UNITED STATES  
DEPARTMENT OF THE INTERIOR  
BUREAU OF LAND MANAGEMENT

FORM APPROVED  
OMB NO. 1004-0135  
Expires: July 31, 2010**SUNDRY NOTICES AND REPORTS ON WELLS**  
*Do not use this form for proposals to drill or to re-enter an abandoned well. Use form 3160-3 (APD) for such proposals.***SUBMIT IN TRIPLICATE - Other instructions on reverse side.**

API 30-015-40549

NFE Federal #14

**Apache Corp.**  
**Proposed Wellbore**

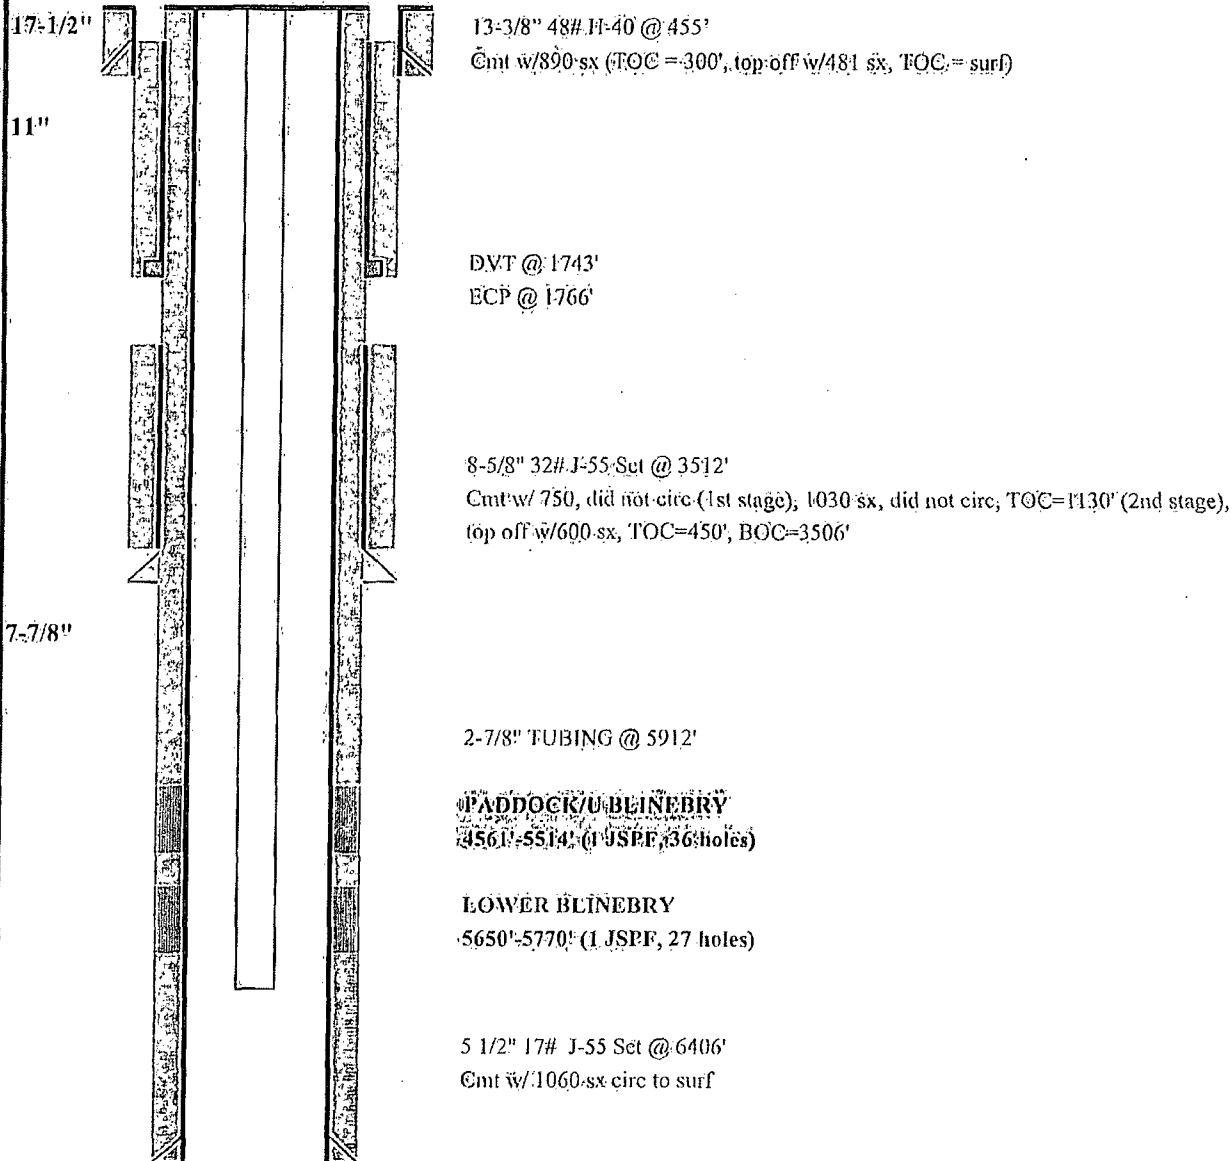
- 1. Must conduct a casing integrity test to maximum treating pressure before any work can be done. Submit results to BLM. The CIT is to be performed on the production casing per Onshore Oil and Gas Order 2.IIL.B.1.h. Submit results to the BLM.**

- 2. Recompletion procedure approved as written.**
- 3. Operator has been approved for this zone, Cedar Lake; Gloreita-Yeso (pool code 96831) which includes the Paddock and the Blinbry, so no NOI is necessary only a subsequent report is needed after pay has been added.**

10. Subsequent sundry required detailing work done and completion report with both formations. Operator to include well bore schematic of current well condition when work is complete.
